Replacement of electrical fuel pump(s) for ROTAX® Aircraft Engines

ATA System: 73-10-00 Fuel system

MANDATORY

SERVICE BULLETIN

Fig. 1

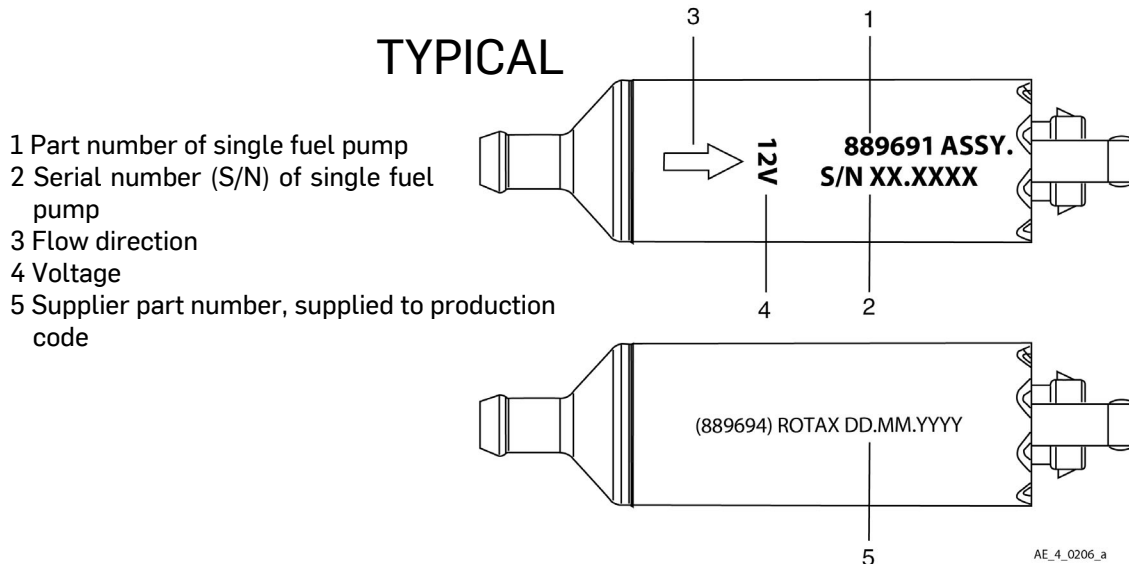
See [Fig. 1](#) and [Fig. 2](#) for information on how to find the part no. and S/N on the fuel pump assy.

NOTE: The fuel pump assembly (including stainless steel box, fuel pumps, check valves and hoses/tubing) serial number may, or may not, be different than the serial number of the individual fuel pumps (See [Fig. 1](#) and [Fig. 2](#)).

Fig. 2

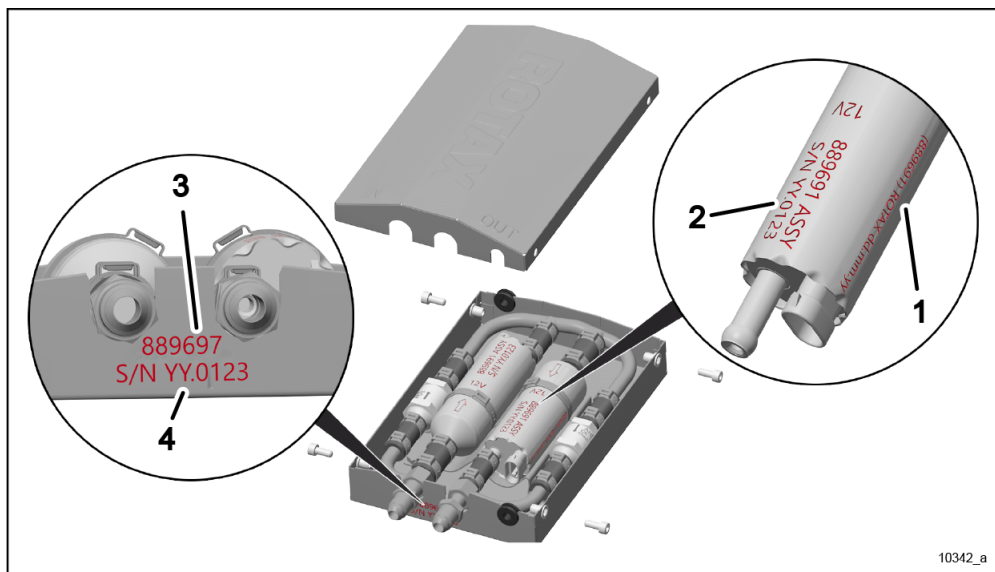
- 1 Supplier part number, supplied to, production code
- 2 Serial number (S/N) of single fuel pump, see Fig. 1
- 3 Part number of complete fuel pump assy. (889696 for UNF or 889698 for metric)
- 4 Serial number (S/N) of complete fuel pump assy. (housing, fuel pumps,...) example (here e.g. 20.0123)

Do not modify the assembly serial number that is engraved on the stainless steel housing. This is the assembly serial number and stays the same regardless of the individual fuel pump serial number.
